6.0 WETLANDS/WATERCOURSES AND BUFFERS COMMENTS AND RESPONSES

Figure 6-2: Pre-Development Drainage Areas
 Salem Hunt
 Town of North Salem, Westchester, New York
 Base Map: Insite Engineering, Surveying & Landscape Architecture, P.C.
 Date: December 1, 2006
 Scale: 1" = 200'

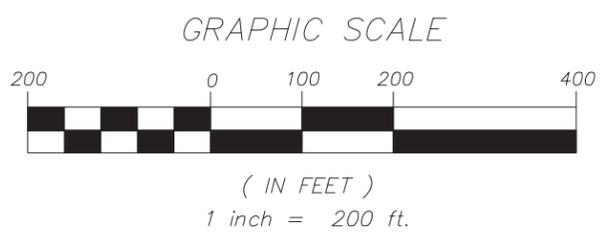
Comment 6-5 (Letter #3 Ms. Marilyn Shanahan, NYCDEP, July 9, 2008): The design-line approach to analyzing drainage adjacent to Wetlands A and C (Design Line 1), and near the access road entrance (part of Design Line 2), may not be appropriate because a point discharge is quantifiable at each point, and a receiving watercourse exists to directly convey the flow. The use of long design lines may mask the impact at specific areas where increased post-development runoff will be discharged from the site. For example, the nine (9) acre drainage area consisting primarily of the septic system absorption area has very limited stormwater management provided (a single swath of grass filter strip is proposed) in the post-development condition, yet no pre-development values for runoff flow rates and pollutant loads are presented for comparison at that specific location because the design line covers the entire frontage along the wetland. With the inevitable change in overland flow that will occur with a change of nine acres from forest to grass/meadow, one expects a significant increase in runoff and in pollutant loads along that stretch of land.

***Response 6-5:** The use of "Design Line" methodology does not preclude the analysis of point source discharges. As identified in the stormwater models included in the SWPPP, each sub-basin within the project site has its own area, runoff curve number, and time of concentration, and accordingly, their own individual peak discharge rates. The*

combination of the sub-basin hydrographs to a design line hydrograph illustrates the overall change in peak discharge to the receiving waters. In the pre-developed condition drainage area 2 does not necessitate a further breakdown into smaller catchments as all the discharge is directed to Wetland C.

Figure 6-5: Proposed Pipe Installation Plan
 Salem Hunt
 Town of North Salem, Westchester, New York
 Source: Insite Engineering, Surveying & Landscape Architecture, P.C.
 Revised: 04/01/09
 Scale: 1" = 50'

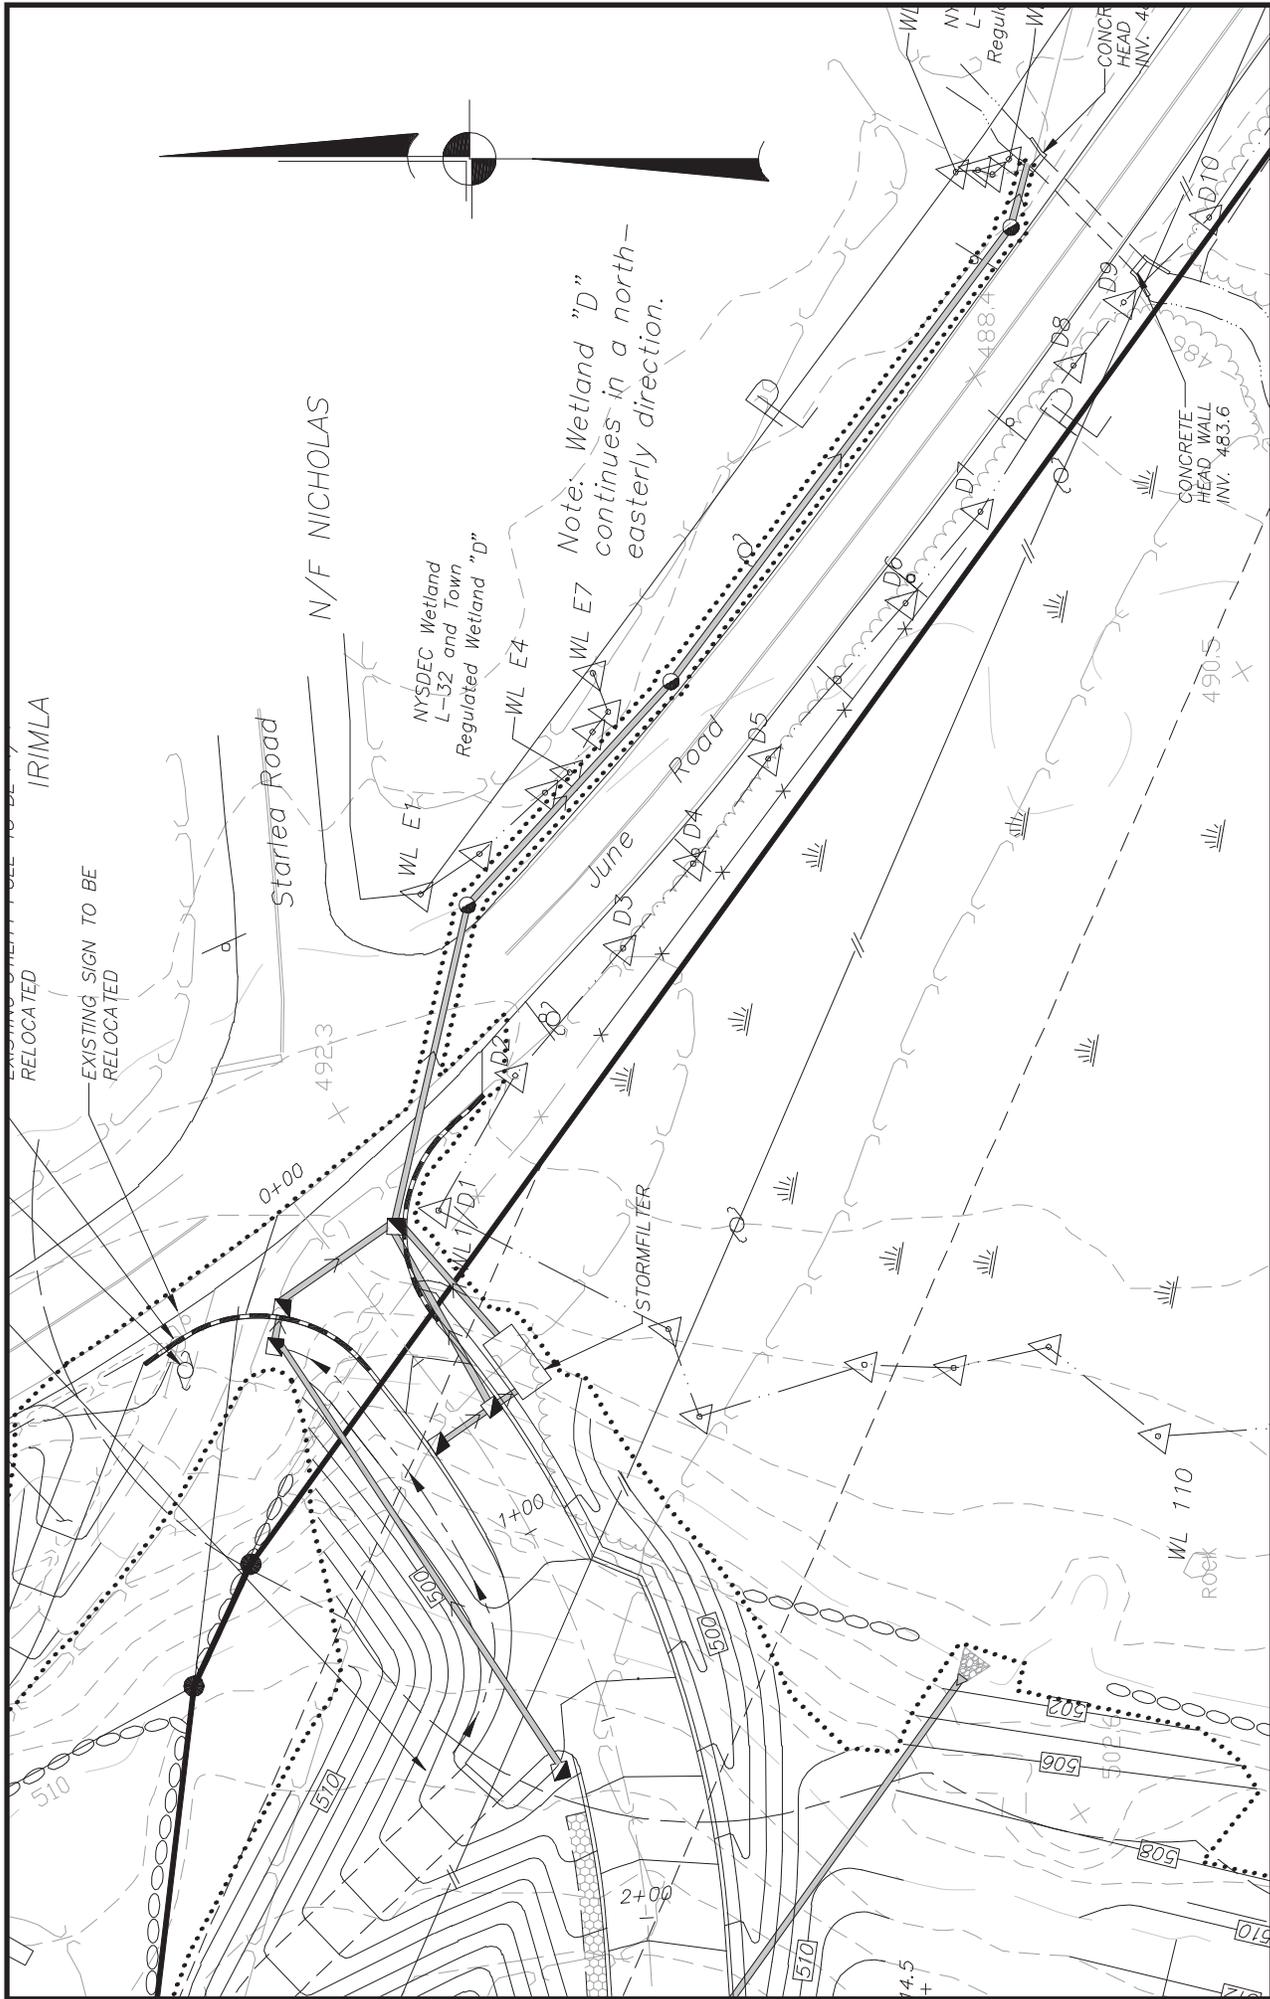
Comment 6-12 (Letter #8 Mr. Frank Annunziata, Hahn Engineering, July 25, 2008): There are numerous places in the document that state that there is no wetland encroachments for this project. This appears to be incorrect based on the information provided. Figure 6-5 "Existing Conditions Map" shows the location of the NYSDEC wetland on the northeast side of June road. The project plans show the location of the drainage discharge line from CB#42 proposed to be constructed in this area and within the NYSDEC wetland. In addition, the plans show an unrealistically narrow width of disturbance for this construction (five (5) feet). A more realistic width, that considers access, placement of spoils, construction materials and erosion control of

a minimum of ten (10) feet should be provided. Also the document should be revised to reflect this encroachment and the need to obtain local, NYSDEC and Army Corps of Engineers (ACOE) approvals.

Response 6-12: *The NYSDEC wetland noted in the comment is located on private property and in the right-of-way of June Road. A Certified Professional Wetland Scientists (PWSs) has recently delineated the boundary of the wetland within the June Road right of way and conducted visual inspections from June Road of the wetland on private property with the project engineer. The delineation and inspections have revealed that, at its closest, the wetland is approximately six feet from the edge of the June Road pavement and that the majority of the wetland is considerably further away from the proposed stormwater line. Figures 6-3 and 6-4 depict existing conditions in the location of the proposed stormwater line adjacent to June Road. A plan showing the stormwater line and the location of the wetland boundary within the right-of-way is shown in Figure 6-5. In the opinion of the PWSs, the wetland is a sufficient distance from the proposed drainage line that there will be no disturbance of the wetland.*
